Charlotte-Mecklenburg Planning Department

SUBJECT: Administrative Approval for Petition No. 2008-031 Mountain Island Promenade, LLC

Attached is the revised site plan for the petition above. This request allows the modification of the proposed site plan as listed below. Since these changes do not alter the intent of the development and meets the requirements of the Charlotte Zoning Ordinance Section 6.207 <u>Alterations to Approval</u>, minor changes, I am administratively approving this plan. Please use these plans when evaluating requests for building permits and certificates of occupancy.

Petition #: 2008-031

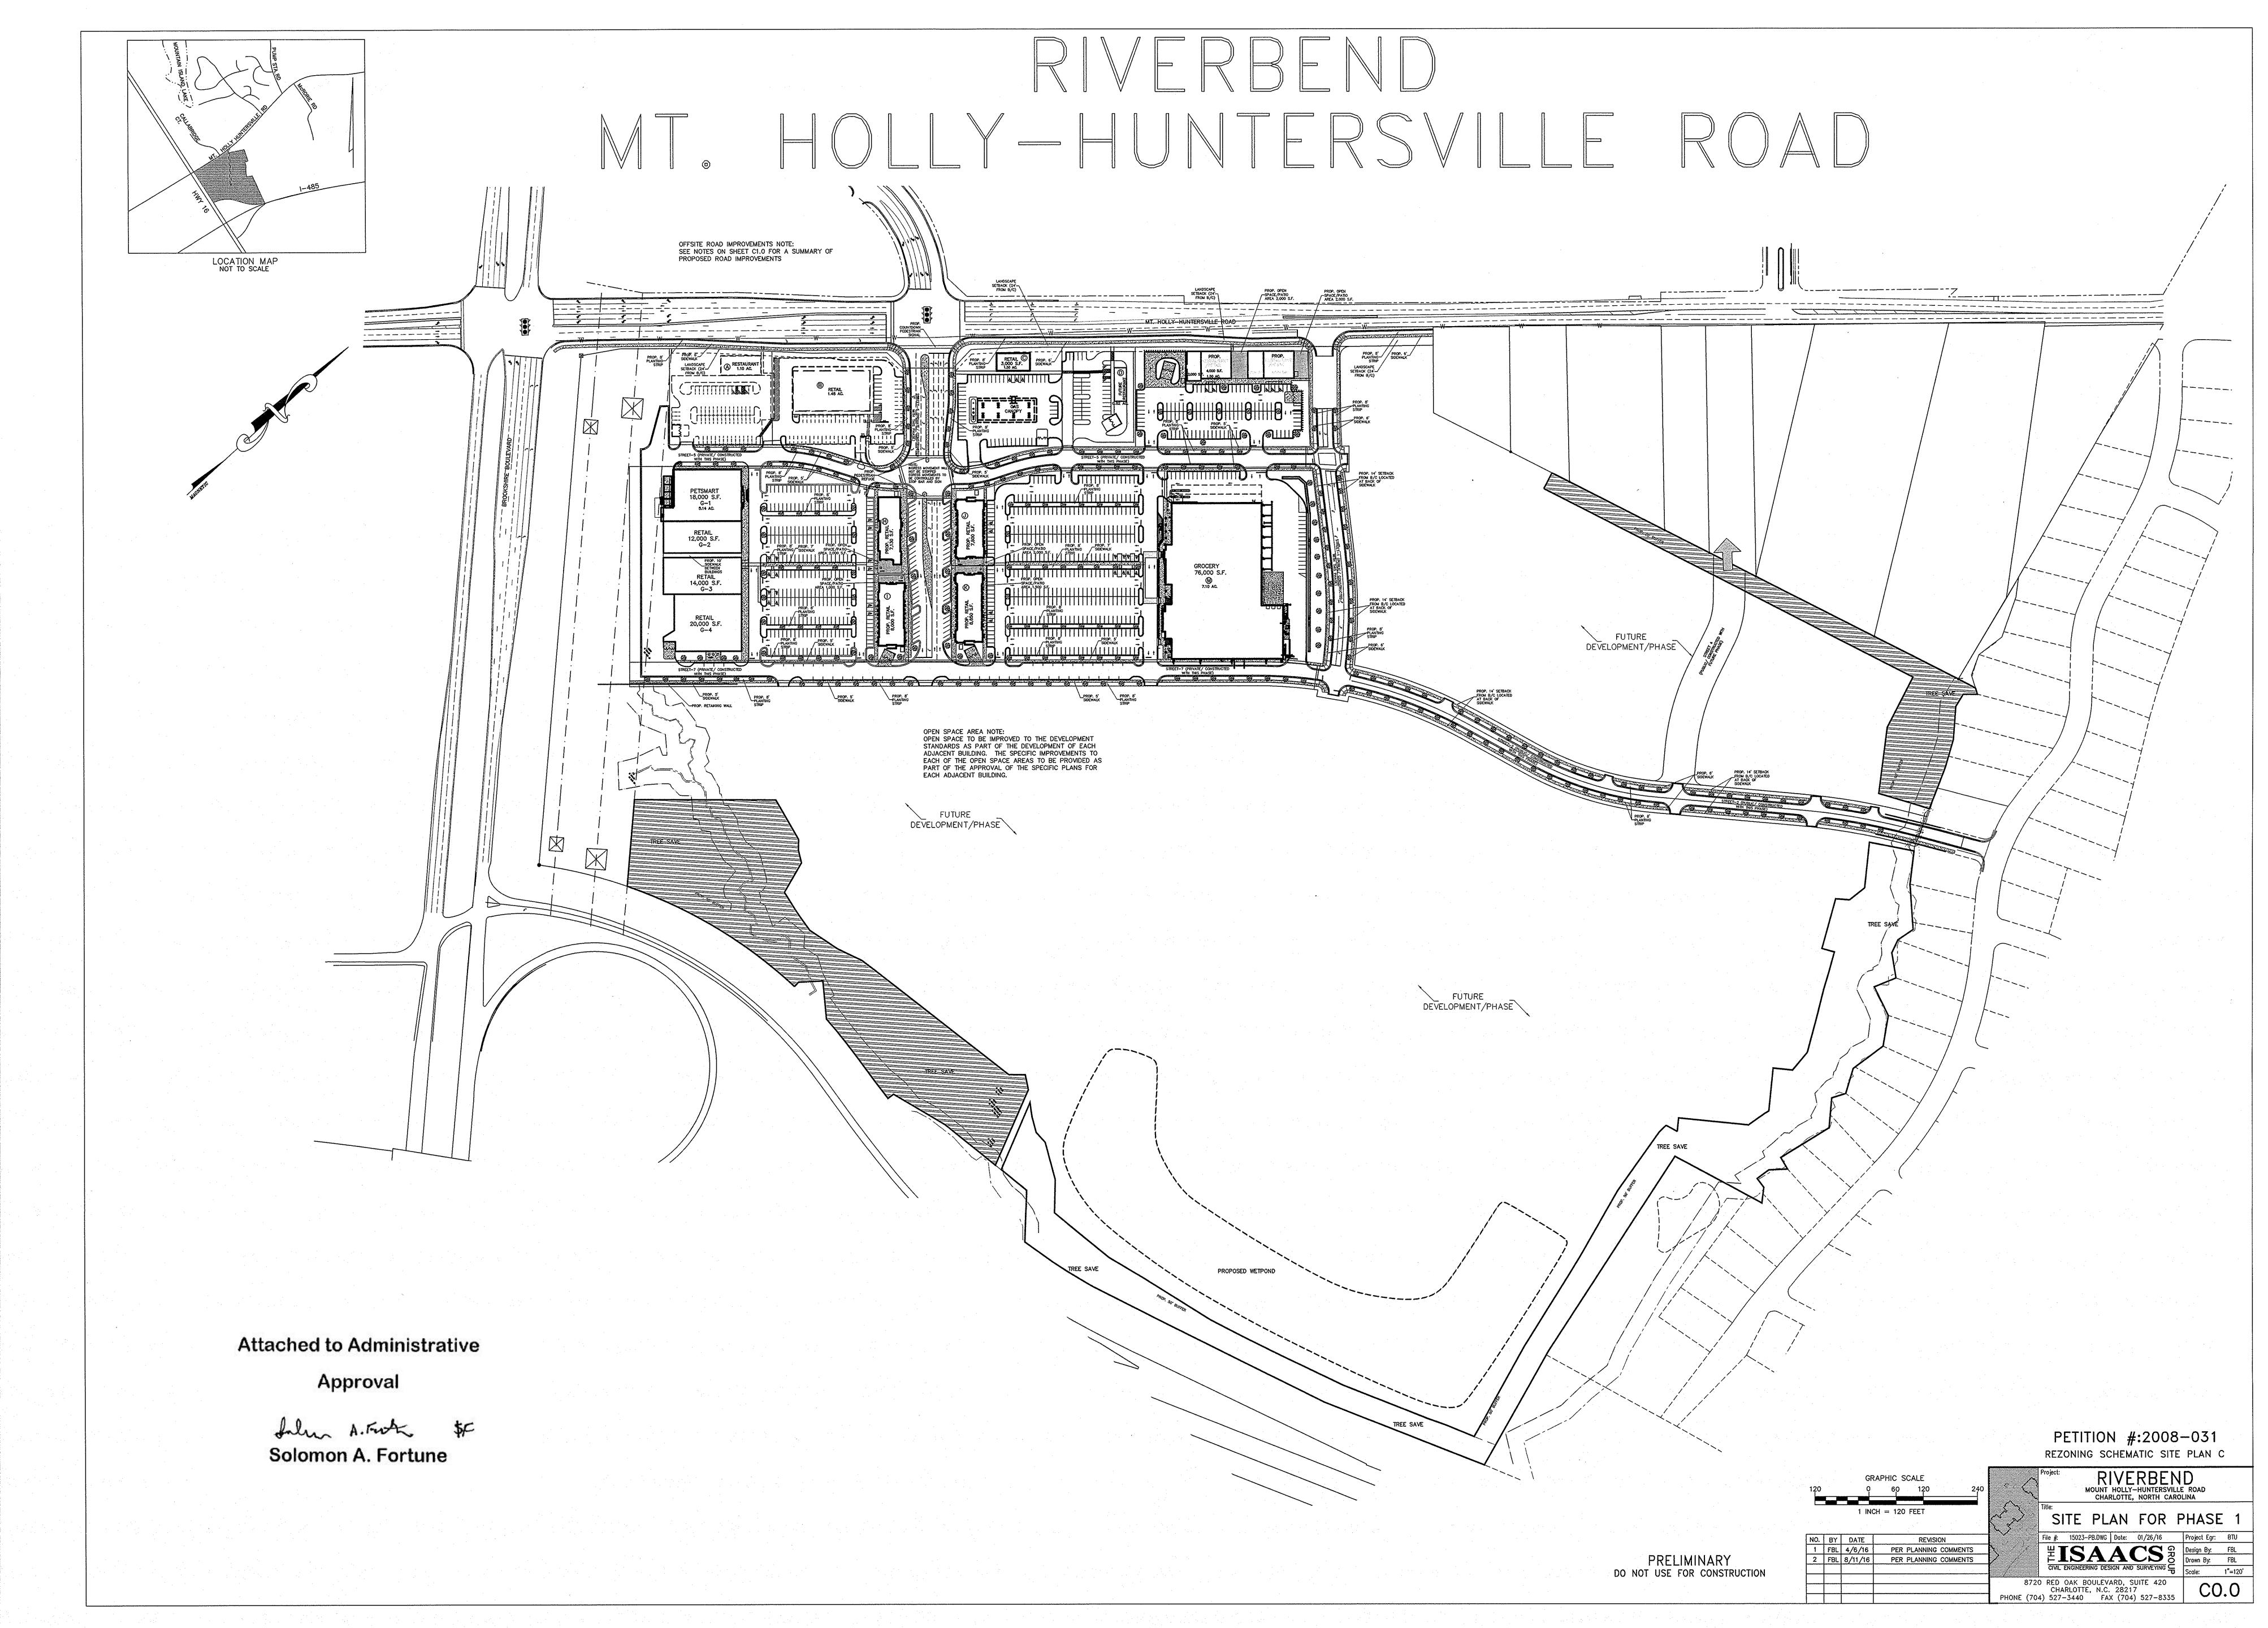
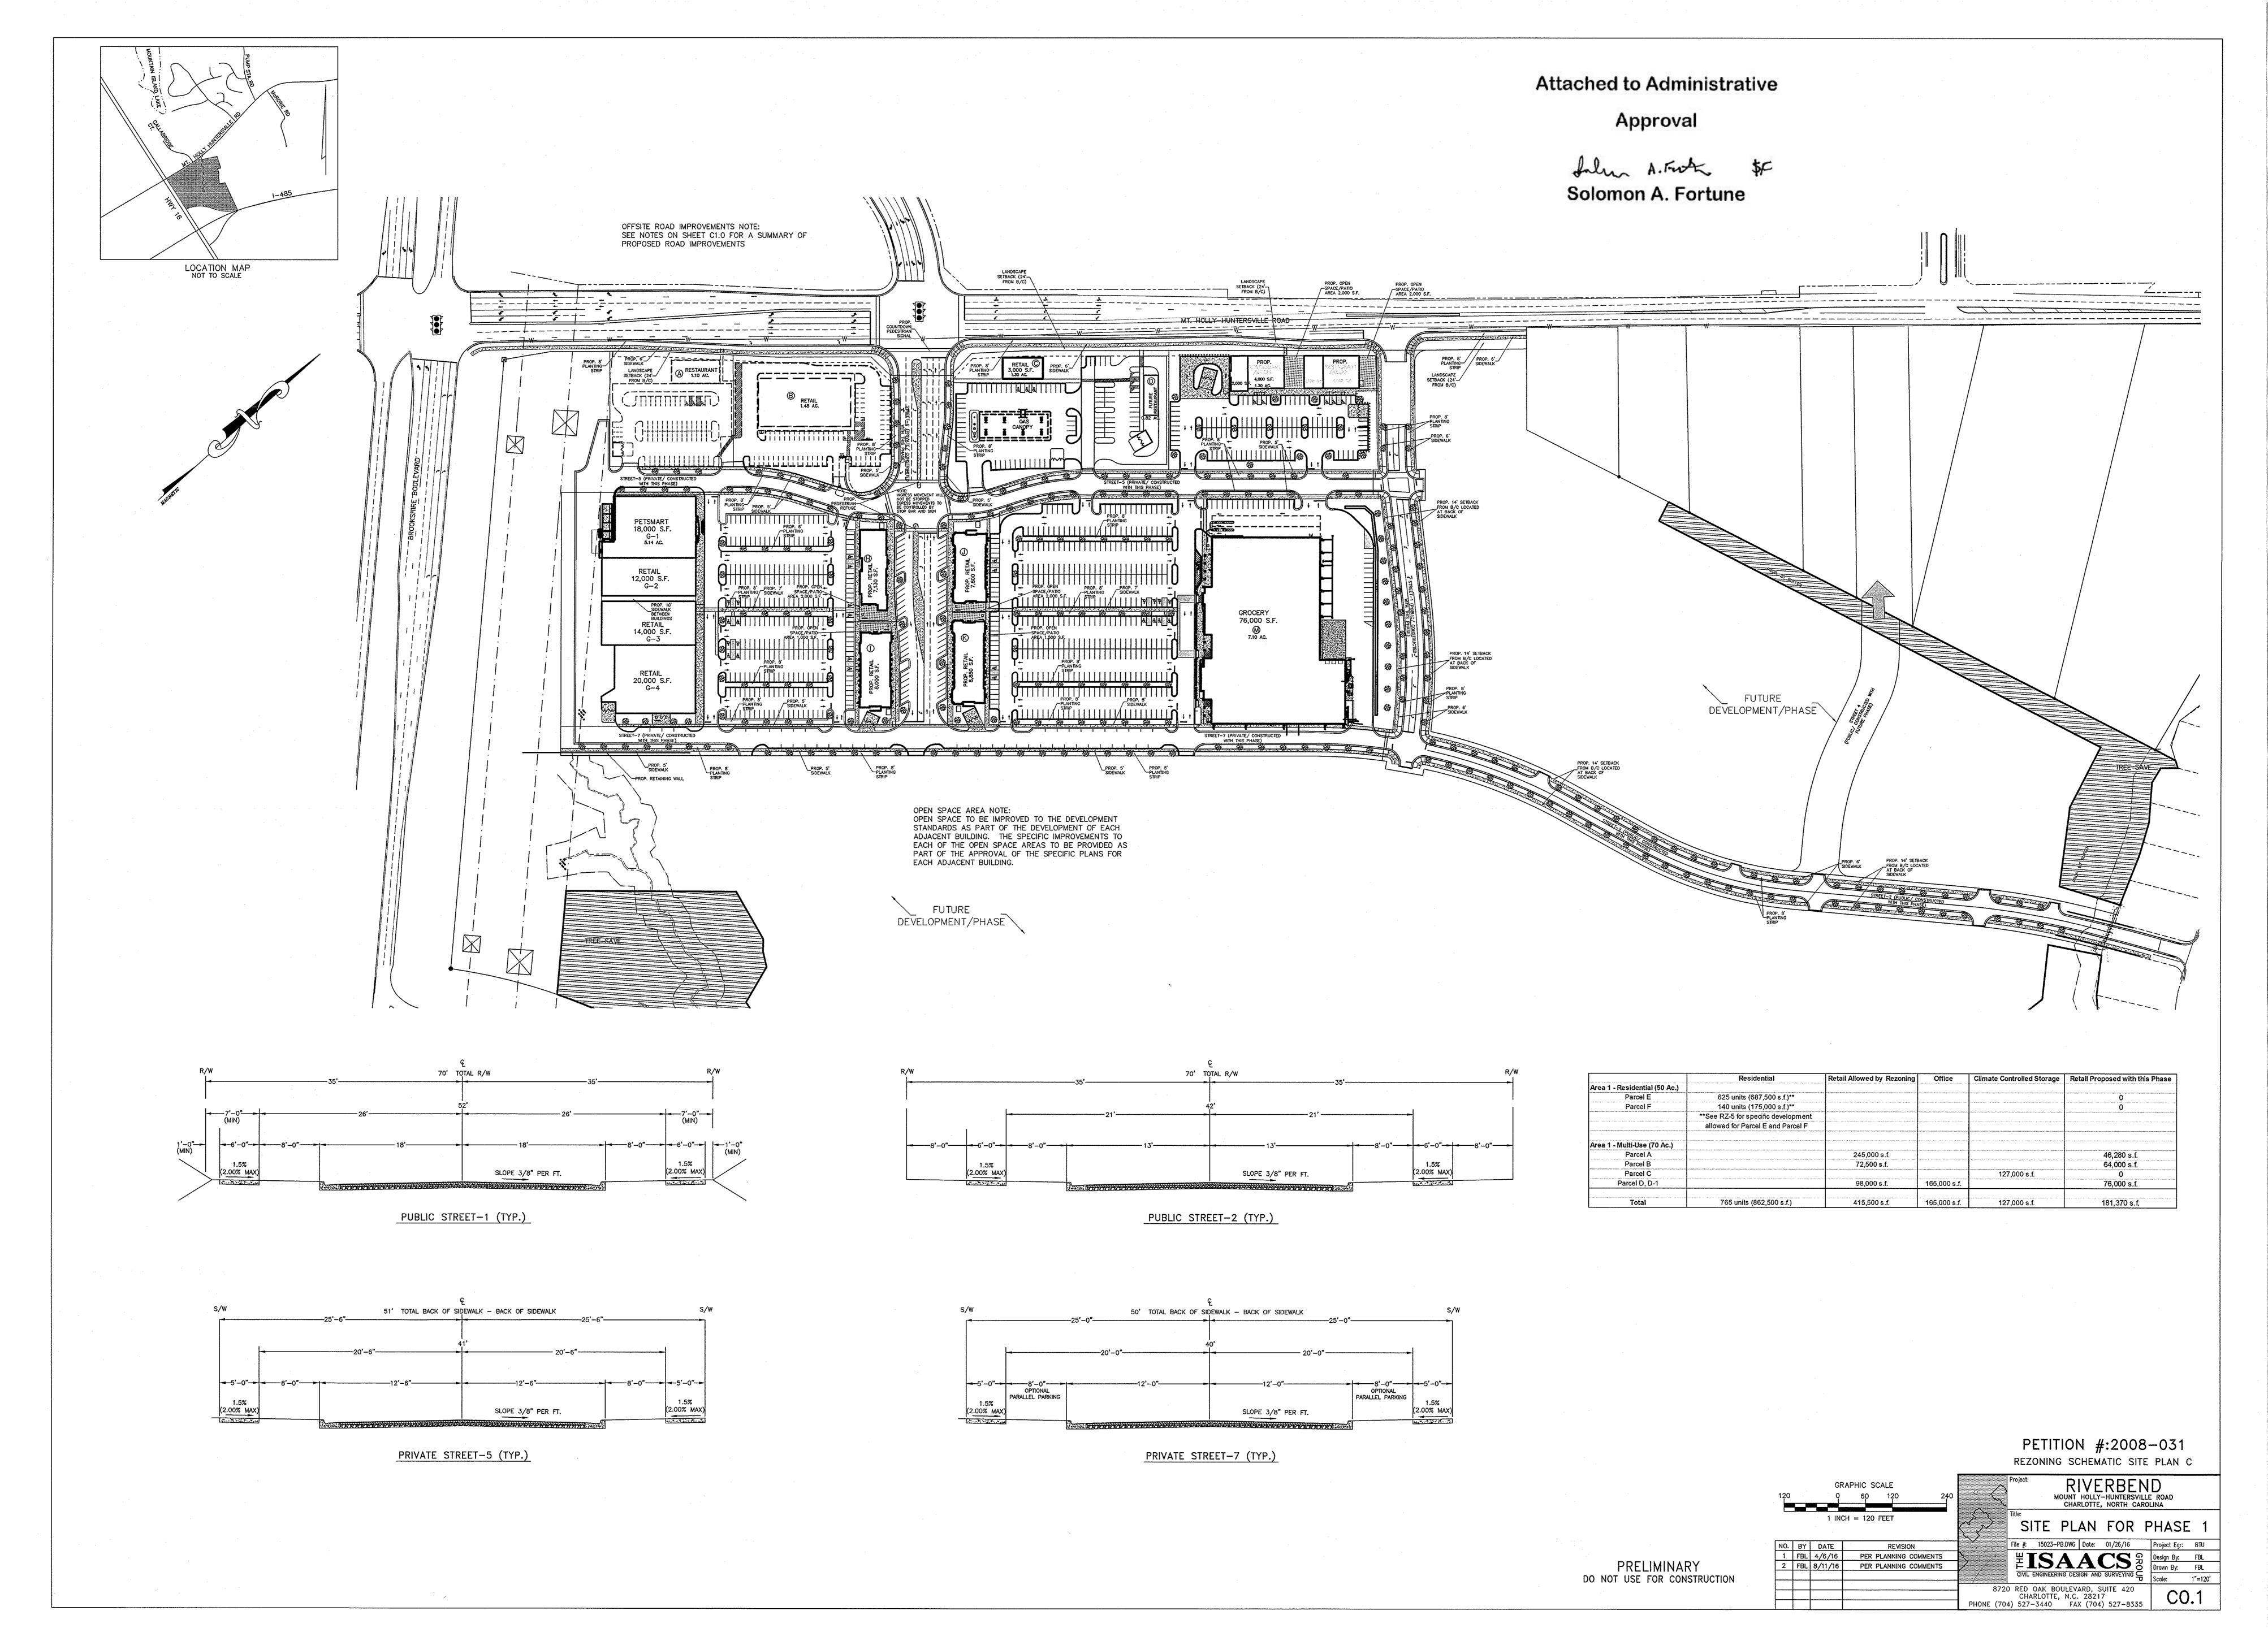
- General layout for proposed retail buildings.
- Note modification: Elevation and review will happen prior to commercial building standards review
- Master site development record
- Open space and green areas are tied to certain buildings being developed.
- Screening wall along proposed internal public street

Please note that no elevation review was completed as part of this review and approval. Each site will need to submit site layout, elevations, and landscaping plan, master development record as each building is developed. Zoning and conditional requirements will be reviewed as each site comes in for development.
